City of Somerville

TO: Planning Board
FROM: Planning, Preservation, & Zoning Staff
SUBJECT: 50 Webster Avenue (Building), P&Z 21-060
POSTED: September 2, 2022

RECOMMENDATION: Approve with Conditions

Predicted Annual Mean Wind Conditions at 50 Webster Avenue and 62 Prospect Street

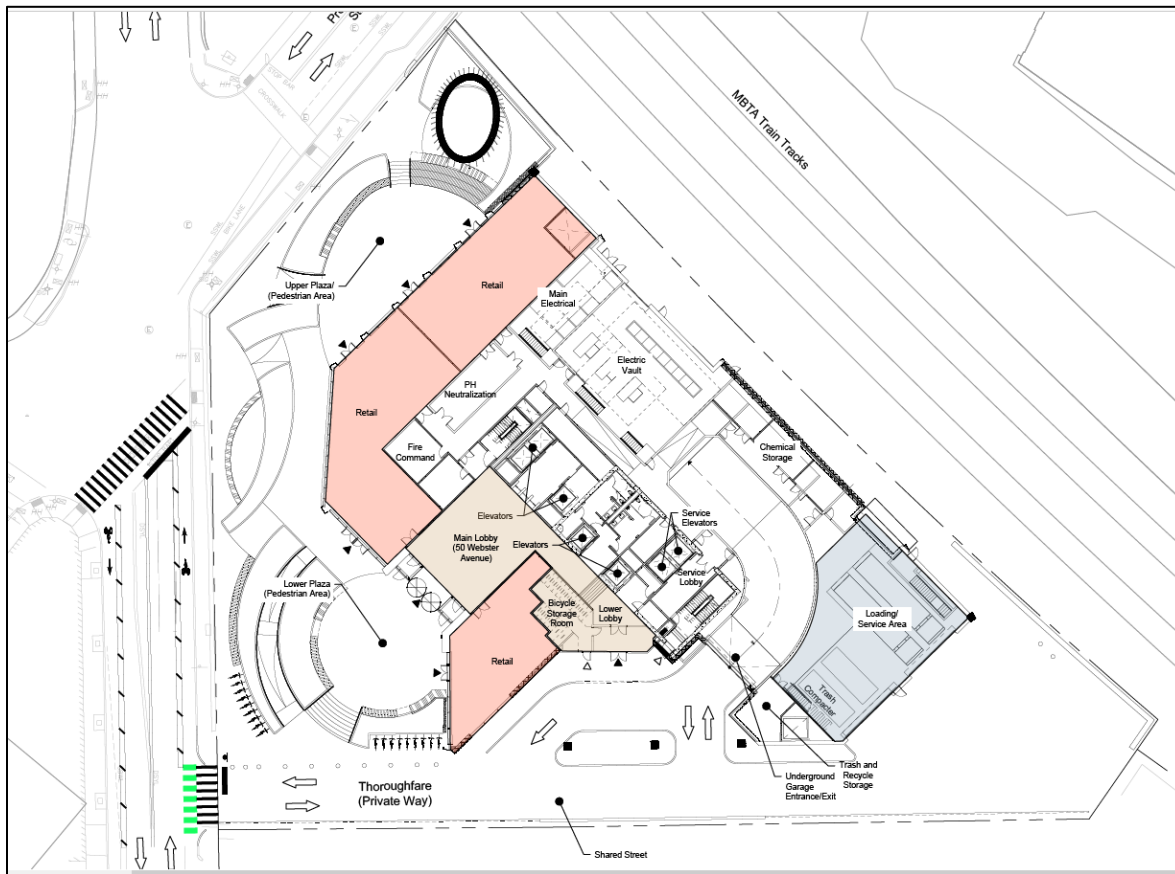
The Applicant has presented a pedestrian level wind study prepared by Rowan Williams Davies & Irwin Inc. (RWDI). The City requires a wind analysis to determine the suitability of various locations for outdoor activities and requires that mean wind speed and effective gust speeds not be exceeded for particular activities more than one percent (1%) of the time without mitigation. The report concludes that no dangerous winds are expected at the site at full build, nor is there any expectation that wind will exceed effective gust criteria. The lobby entrances have appropriate comfort conditions, and the public sidewalks and the majority of on-site walkways are predicted to be comfortable for walking. The report does note that location of proposed retail entrances and some building corners will be exposed to less than desirable winds, but mitigation strategies have been suggested. The pedestrian level wind study recommends several mitigation strategies to address wind levels, including landscaping, canopies, and screening. The proposed shade trees and anticipated future development are both noted as measures expected to have a sufficient mitigating effect on wind on the site.

Illustrative Site Plan (from updated TAP, revised August 2022)

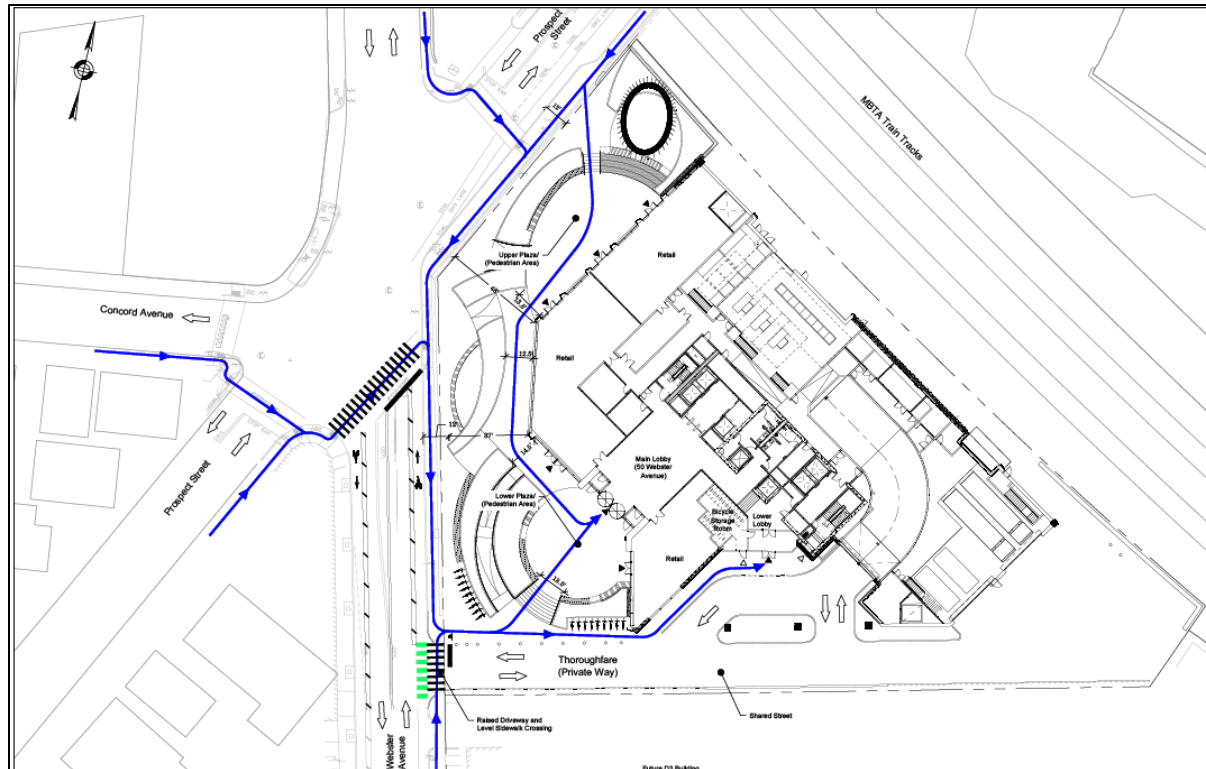
The Illustrative Site Plan (above and within the included updated TAP) shows how the building's ground floor integrates with the proposed civic space and thoroughfare. Retail spaces and the main lobby are accessible via the civic space, while the lower lobby, grade-level long-term bicycle parking, parking garage, garage-level long-term bicycle parking, and loading/service area are accessible via the thoroughfare.

Bicycle Access Plan, excluding legend (updated TAP)

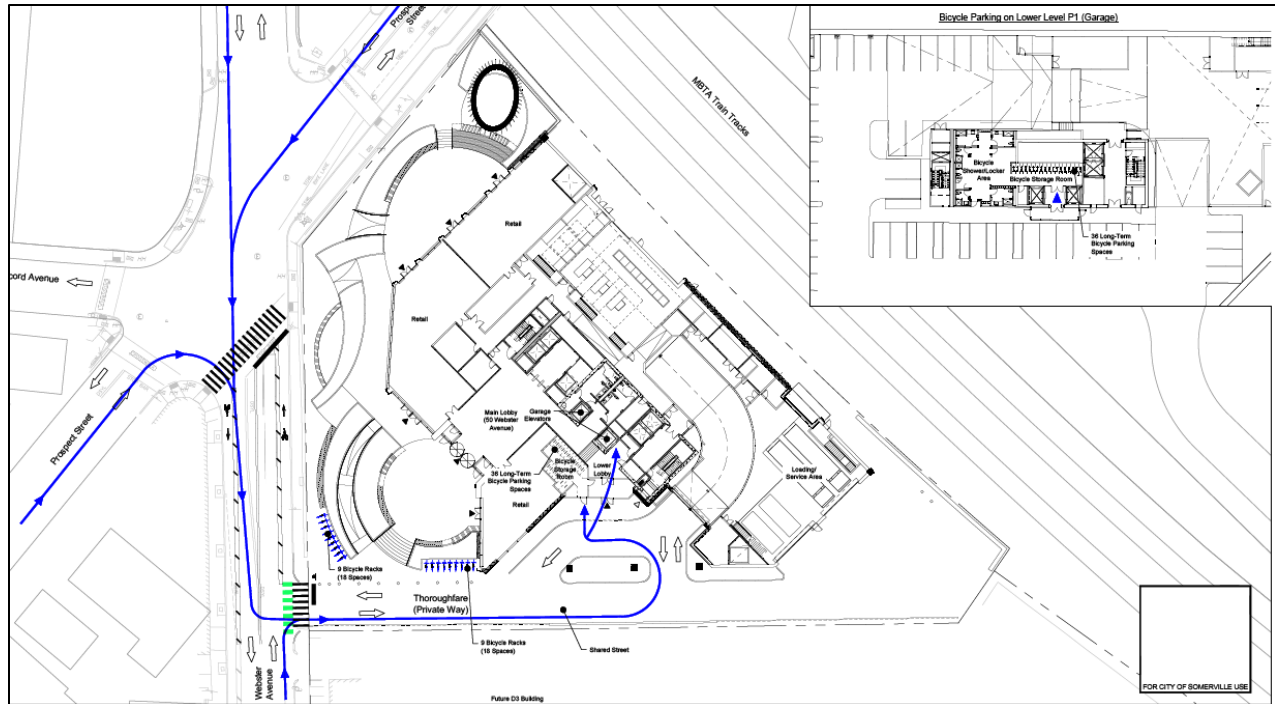
The updated TAP's Bicycle Parking Plan describes how the project will provide at least 18 short-term bicycle parking spaces and 71 secure, long-term bicycle parking spaces, as required by zoning. The short-term bicycle parking will be provided in outdoor bicycle racks within the civic space near the building's primary entrances, and the long-term bicycle parking spaces will be within the building, half at grade level via an entrance next to the lobby, and half on the garage level. The TAP states that cyclists will access the underground bicycle storage room from the lobby using designated elevators. Bicycle parking spaces to be accessible without lifting or carrying a bicycle over any steps or stairs.

- The Applicant will provide at least fifty percent (50%) of the required long-term bicycle parking at-grade or via a ramp with a slope of less than 5% or less than 8% with a landing every thirty (30) feet, as demonstrated in the updated Transportation Access Plan.
- To mitigate transportation impacts, the east side of Webster Avenue along the frontage of the site shall be improved with a curb-separated bikeway or its
